Subject: Submittal of Replacement Pages to Update the NAC-UMS® FSAR from Revision 3 to Revision 4 (Docket No. 72-1015)

Attachment 1: 10 CFR 72.48 Evaluation Summary Report for the NAC-UMS[®] Universal Storage System (Period Covered: March 2004 – November 2004)

Attachment 2: 10 CFR 72.48 List of Changes for the NAC-UMS[®] Universal Storage System FSAR, Revision 3

72.48 Determination Checklist ID #NAC-04-UMS-009

Figure 3.4.2-1 Universal Storage System Welded Canister Closure

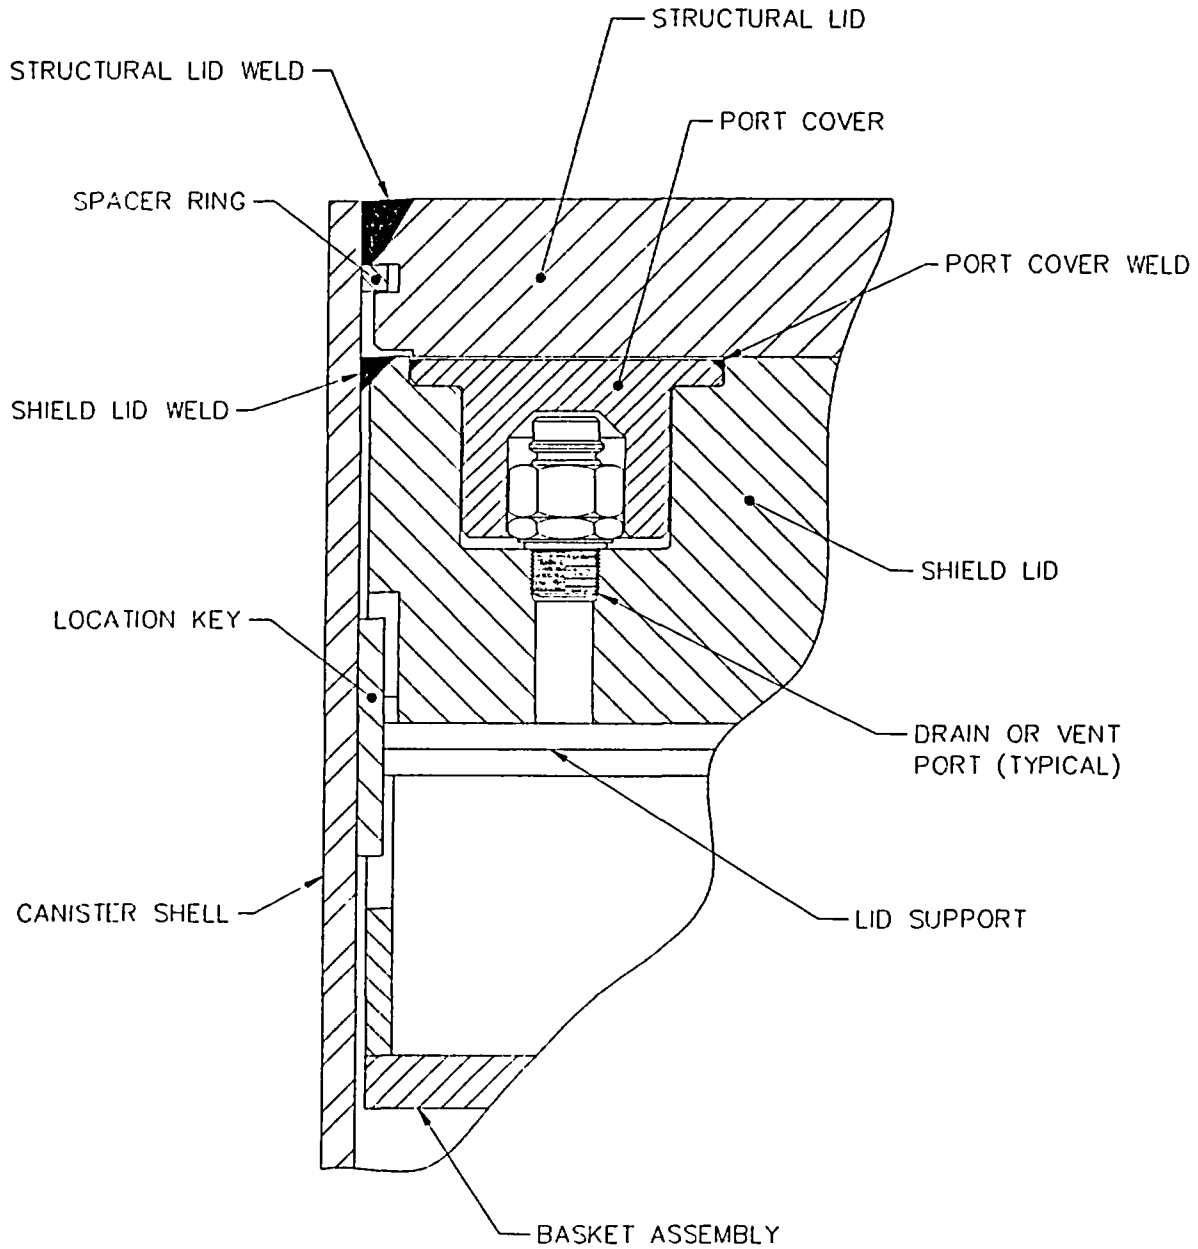
Chapter 3, Page 3.4.2-1 (Figure 3.4.2-1); Chapter 7, pages 7.1-3, 7.1-5, 7.1-8 (Figure 7.1-2) & 7.5-1; Chapter 12, pages 12C3-9, 12C3-12, 12C3-13, 12C3-16, 12C3-19, 12C3-20, 12C3-22 & 12C3-24.

Figure 4.4.1.3-2 Three-Dimensional Transfer Cask and Canister Model - BWR

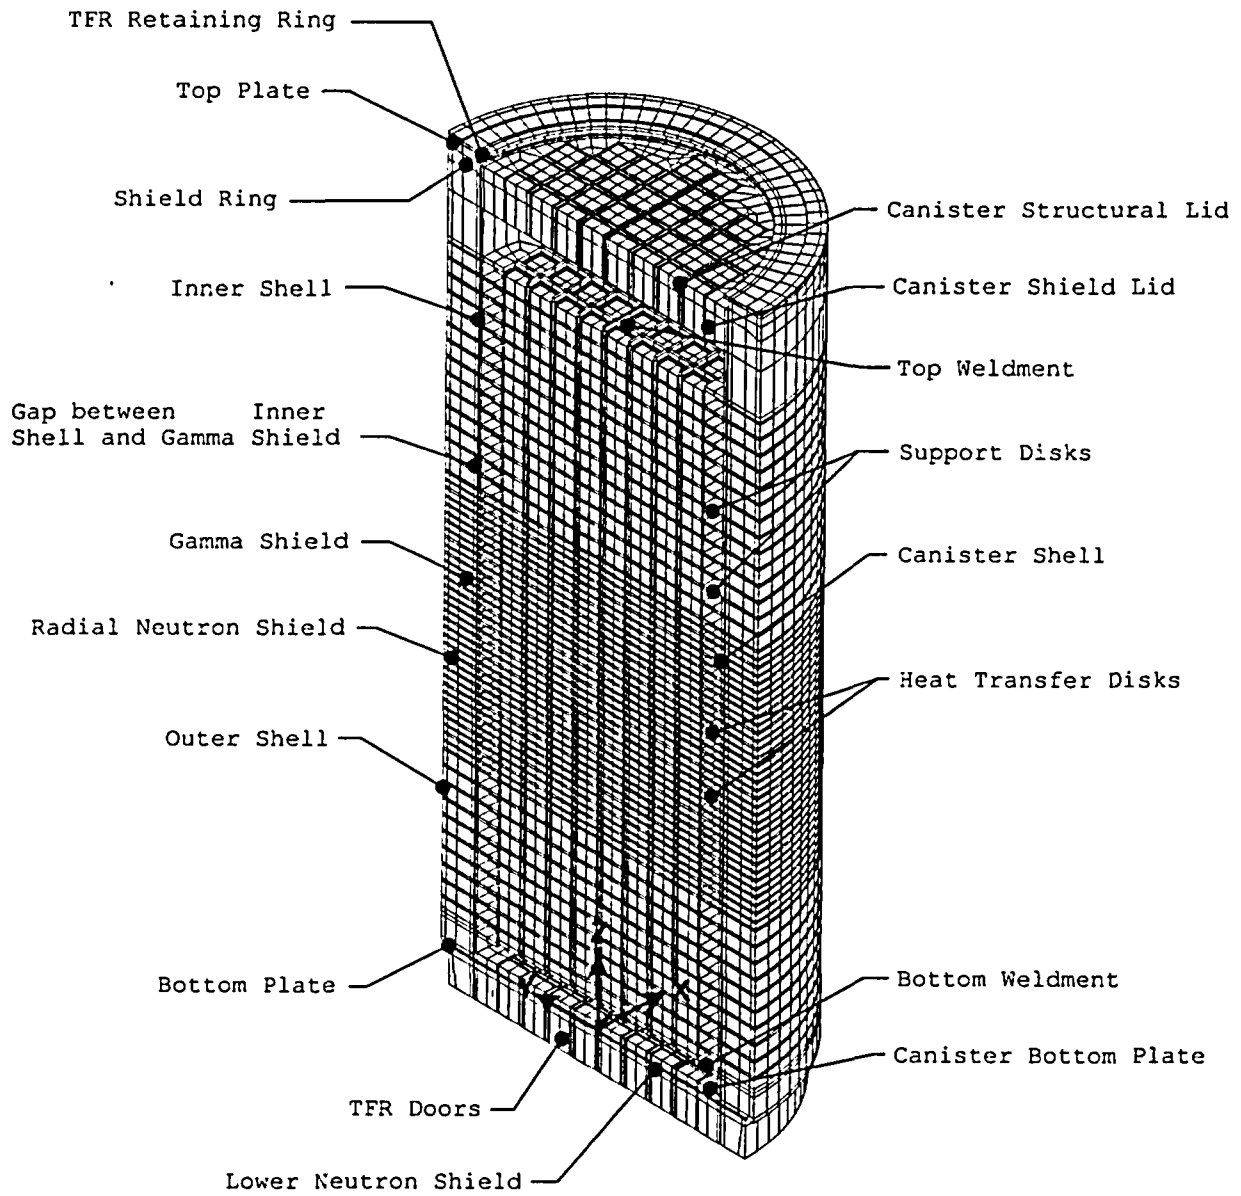
Revises Chapter 4, Sections 4.4.1 & 4.4.3, to add saturated steam to the media considered in the thermal analysis for transfer conditions.

This DCR(L) revises the description of the thermal models and transient analyses for the transfer conditions to reflect the fact that the media inside the canister is considered to be saturated steam during the first four hours of the vacuum conditions. The details are presented in NAC Calculation Nos. EA790-3006, Rev. 0; EA790-3007, Rev. 0; EA790-3206, Rev. 6; and EA790-3207, Rev. 1. There is no change in the thermal models and analyses.

Page 4.4.1-27	72.48/DCR(L) 790-FSAR-3A	Section 4.4.1.3, 2 nd paragraph – added sentences 5 & 6
Page 4.4.1-28	72.48/DCR(L) 790-FSAR-3A	1 st full paragraph, 1 st & 2 nd sentences – revised throughout
Page 4.4.1-30, Figure 4.4.1.3-2	72.48/DCR(L) 790-FSAR-3I	Text box – deleted “(water/helium)”

Figure 4.4.1.6-1 Two-Dimensional Fuel Tube Model: PWR Fuel

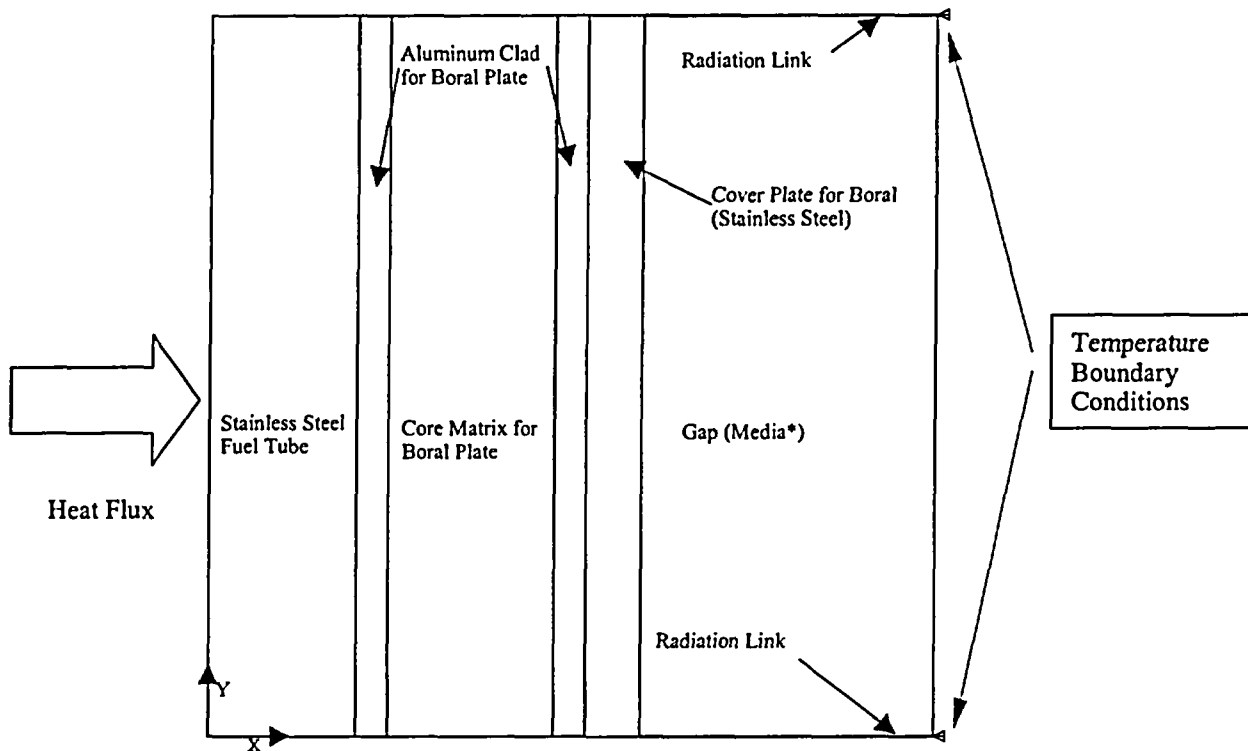
Chapter 4, pages 4.4.1-2, 4.4.1-30 (Figure 4.4.1.3-2) 4.4.1-35, 4.4.1-38, 4.4.1-41 (Figure 4.4.1.6-1), 4.4.1-42 (Figure 4.4.1.6-2), 4.4.1-43 (Figure 4.4.1.6-3), & Section 4.4.3 (page 4.4.3-1).

As shown in Figure 4.4.1.6-1, the PWR model includes the fuel tube, the BORAL plate (including the core matrix sandwiched by aluminum cladding), the stainless steel cladding and the gap between the stainless steel cladding and the support disk or heat transfer disk. Four types of media are considered in the gaps: helium, water, a vacuum and saturated steam.

*Media can be water, vacuum, helium or saturated steam.
